1 Products affected

2 Type of change

Product Change Notification					PCN TA35 Change of product design		
owner	creation date	release date	released by	change order	rev	page	D10-070-810
signergu	20.01.2023	08.02.2023	schulejo	2025494	A	1 of 6

1-pole types

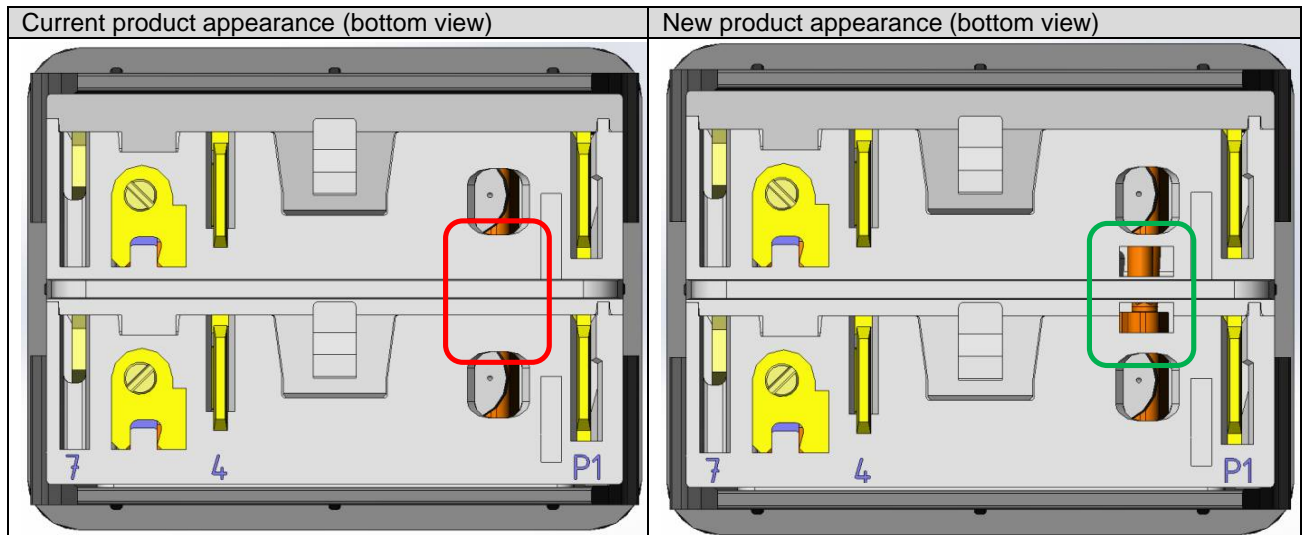
- Additional openings in the bottom of the housing
